**CONSOLIDATED EDISON COMPANY OF NEW YORK, INC.
INDIAN POINT NUCLEAR GENERATING UNIT NO. 3**

**THIRD SUPPLEMENT TO:
PRELIMINARY SAFETY ANALYSIS REPORT**

Supplement 2 to the Preliminary Safety Analysis Report for Indian Point Nuclear Station No. 3 consists of responses to the AEC Questions on Containment Design requested in the letters of February 19, 1968 and July 16, 1968 to Consolidated Edison Company of New York.

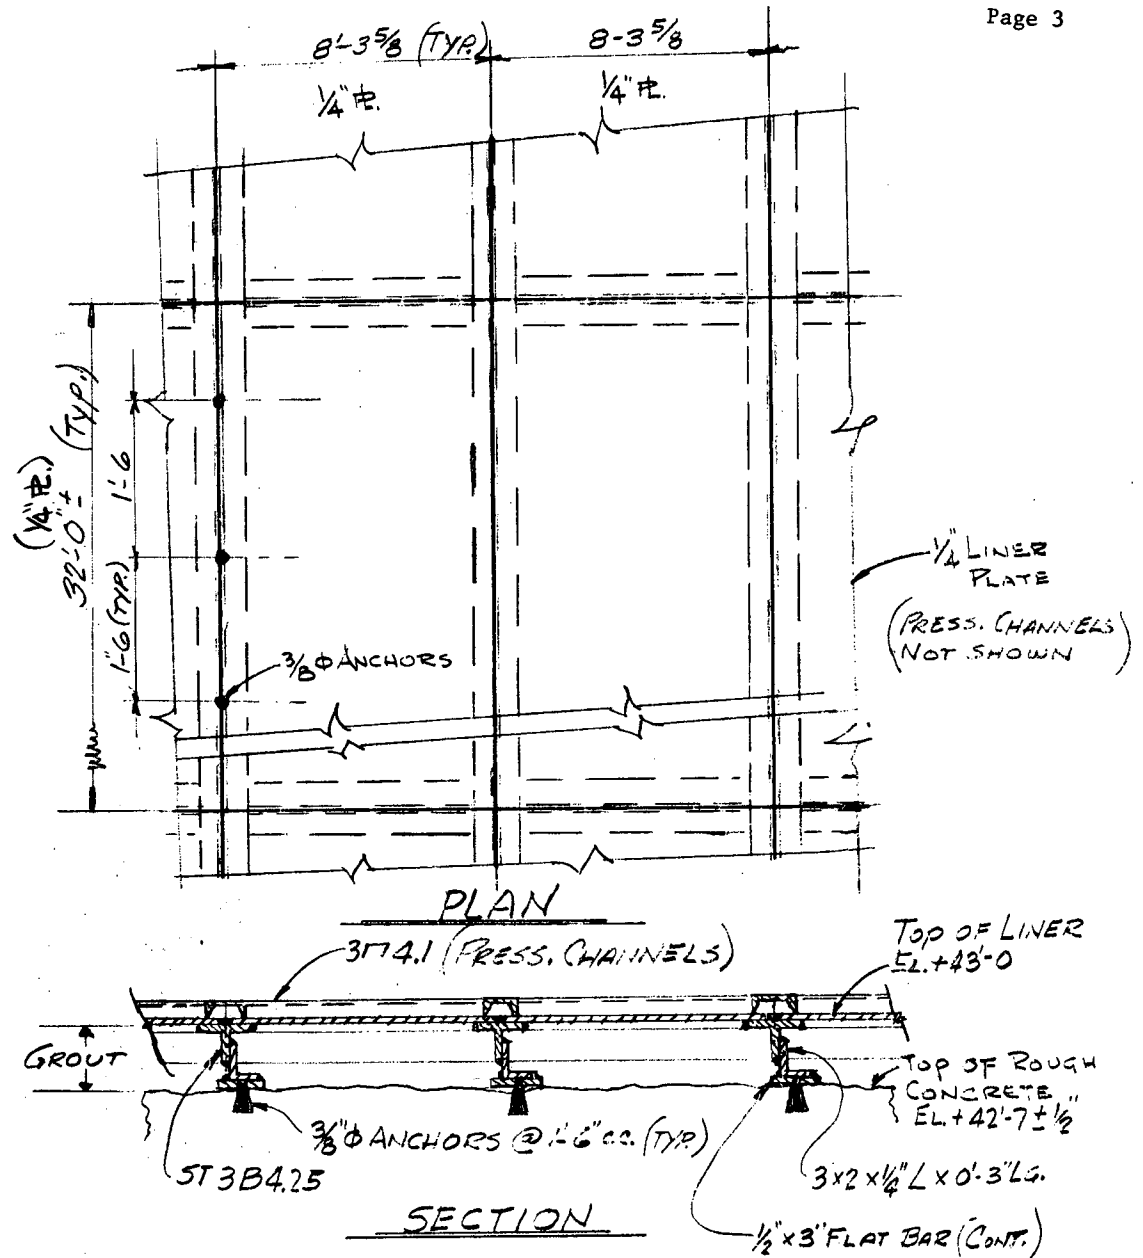
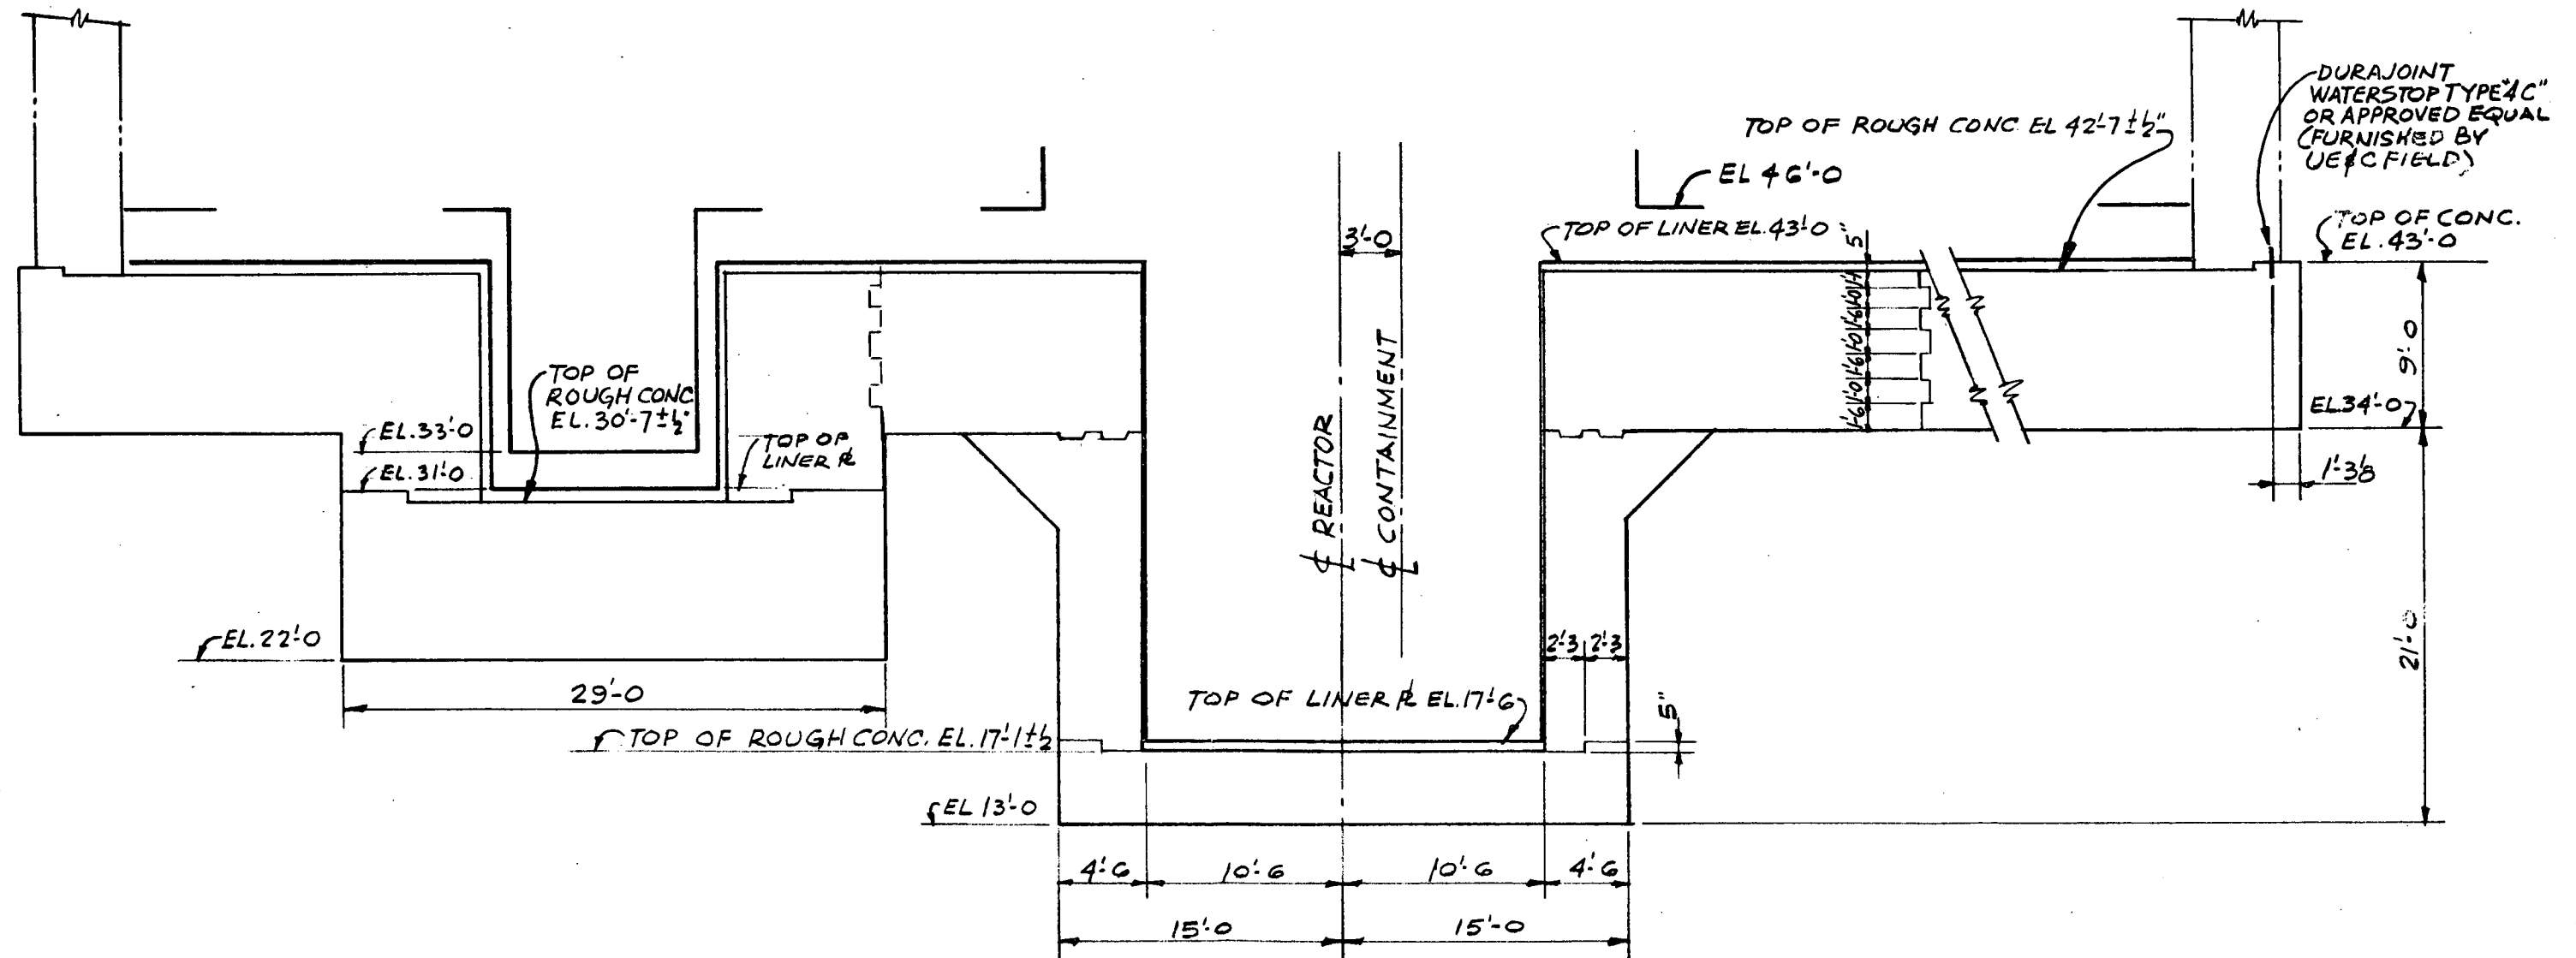
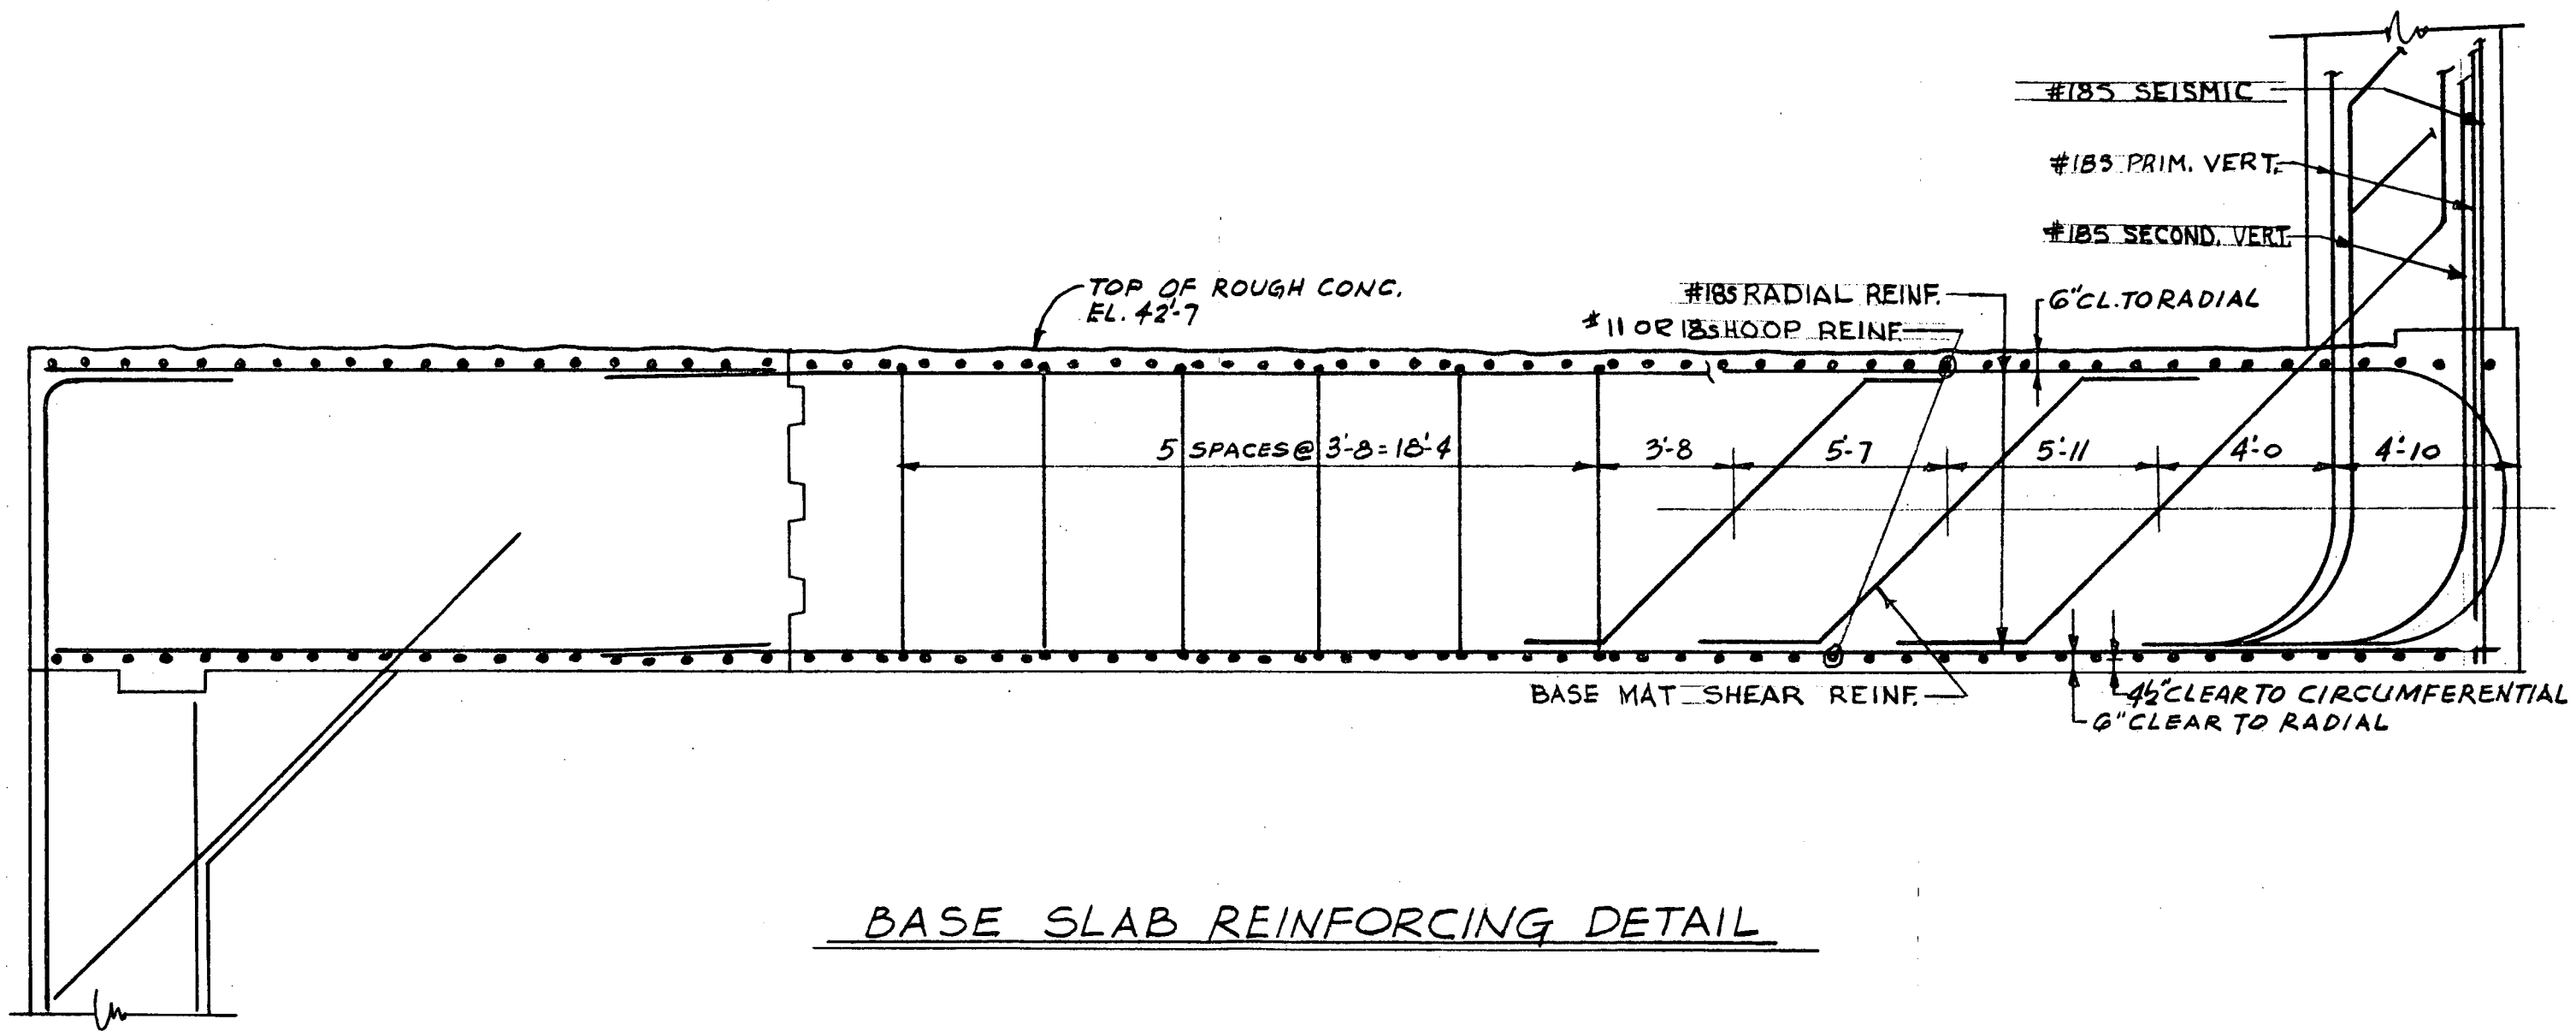
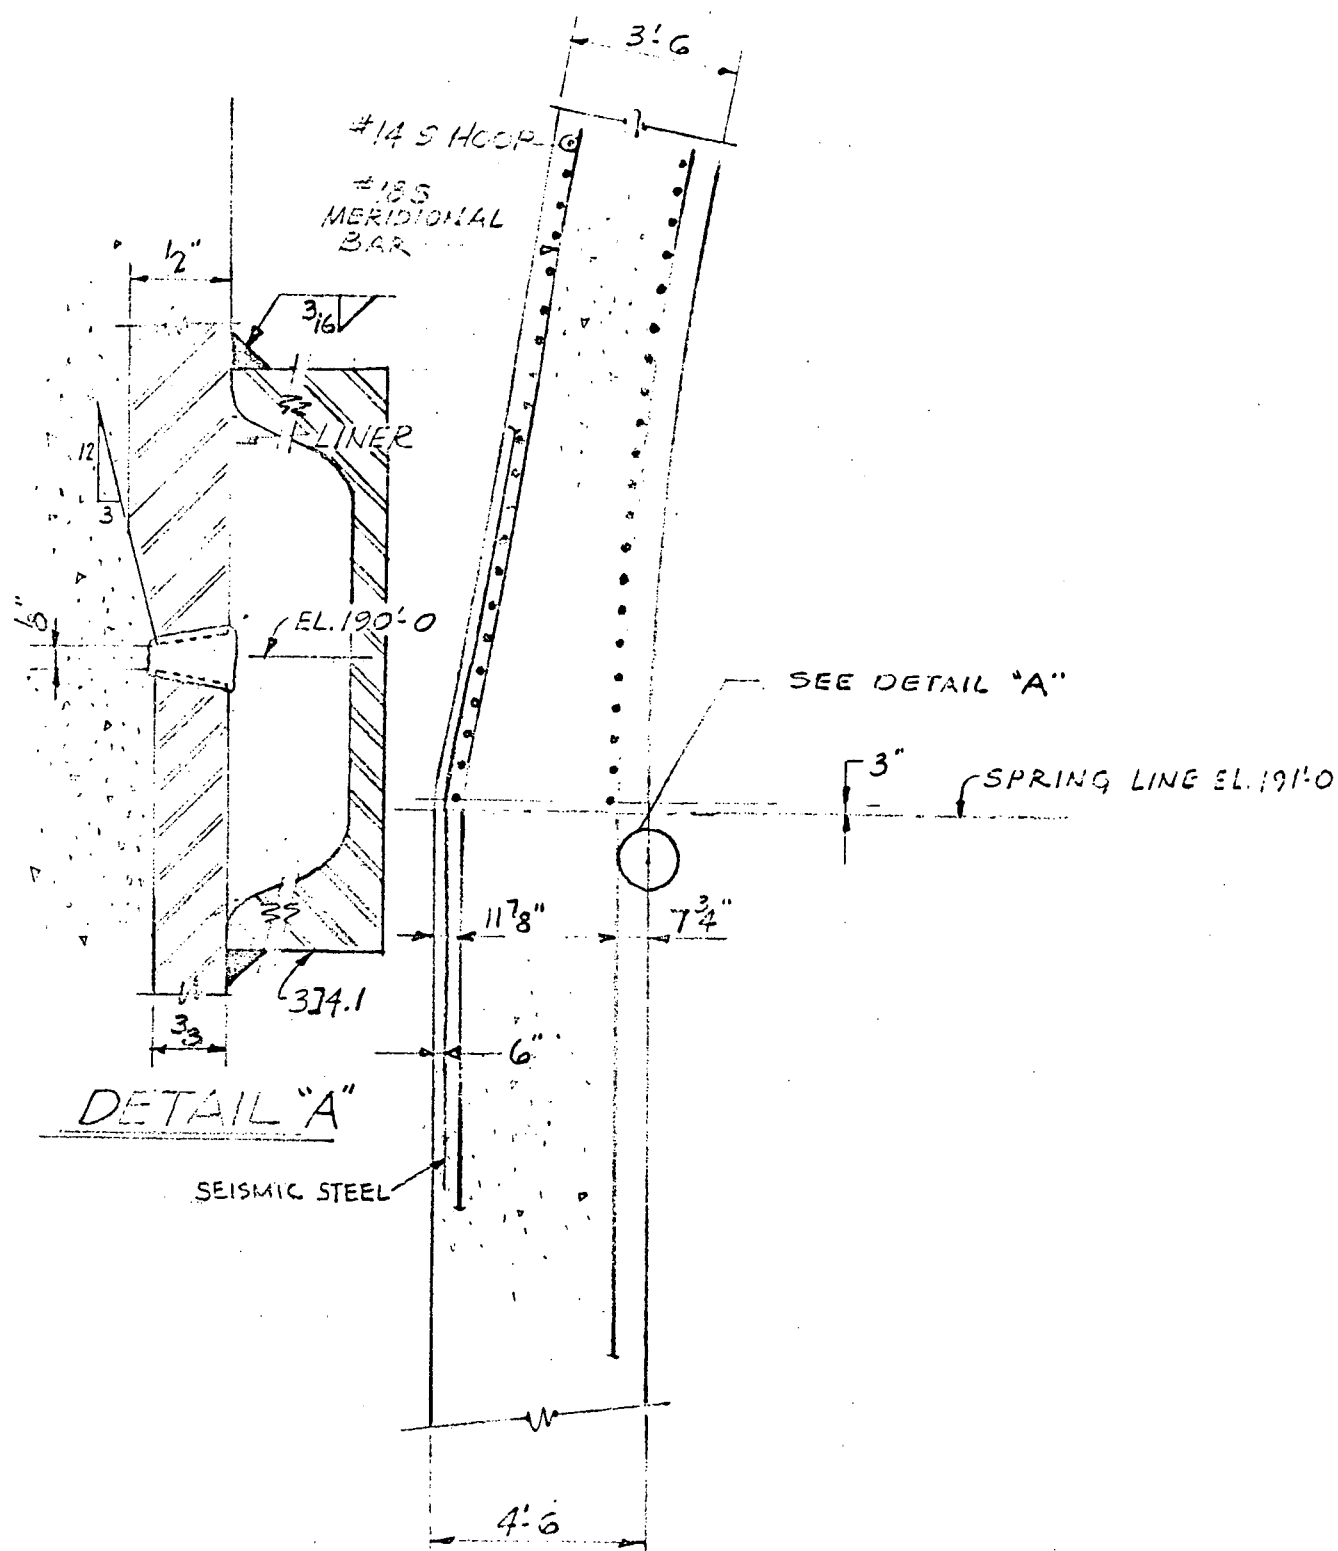
- (a) A preliminary design drawing of the containment presenting details of the base slab, dome-cylinder junction, cylinder-slab junction, showing reinforcing and liner features, including liner anchors.

The preliminary design drawings are given in Figures 2.4(a)-1 through 2.4(a)-4. The preliminary design drawings for the dome-cylinder junction will be given in a subsequent supplement to the PSAR.

The shear reinforcing is placed in the mat to accomodate redistribution of internal forces should a diagonal crack occur. The density of the reinforcing steel in the mat is including the wall dowels in 11 lb/cu. ft.

The shear stresses in the inclined stirrups in the mat are calculated for the 1.25P loading condition which is the most severe loading condition for shear considerations due to the uplift from the design earthquake with only 2% critical damping. Formula (17.5) of the ACI 318-63 Code is used to calculate the shear stresses. The anchorage bond stresses in the bars are calculated and compared with the allowable bond stress of $.8 \times .6 \sqrt{f'_c} = .262$ psi recommended in Chapter 18 of the ACI-318 Code. In no case is the allowable bond stress exceeded. The following is a table of the shear and anchorage bond stresses for the stirrups:

There are two types of radial shear reinforcing; the inclined stirrups and the secondary vertical bars which are bent across the wall. The inclined stirrups are mechanically anchored by hooking them around the vertical bars. Each secondary vertical bar is terminated further up the wall by splicing it to a #11 bar and mechanically anchoring this bar with a 180° hook.

Figure 2.4(b)-1
Supplement 2

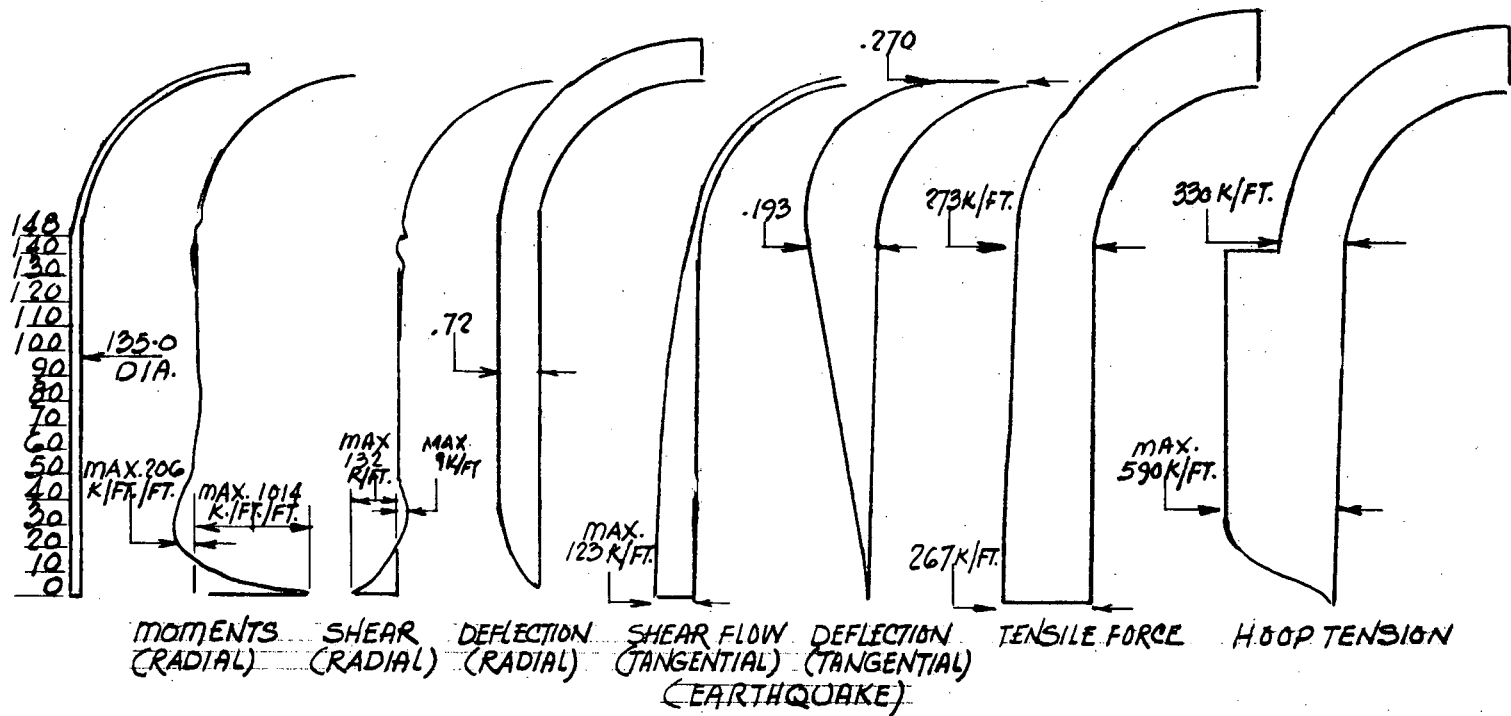
- (b) Scaled load plots for moment, shear, deflection, longitudinal force, and hoop tension, in order that an appraisal can be made of the significance of the various loadings which influence the containment design. Provide these plots for several containment heights for the following loadings: dead, pressure, operating basis earthquake (smaller earthquake), wind, liner thermal (normal and accident) and concrete thermal (normal and accident).

The design loads resulting from the factored load equations presented in Section 5.1.2.4 of the PSAR are shown in Figures 2.4(b)-1 through 2.4(b)-3. Individual load plots are shown in Figures 2.4(b)-4 through 2.4(b)-8.
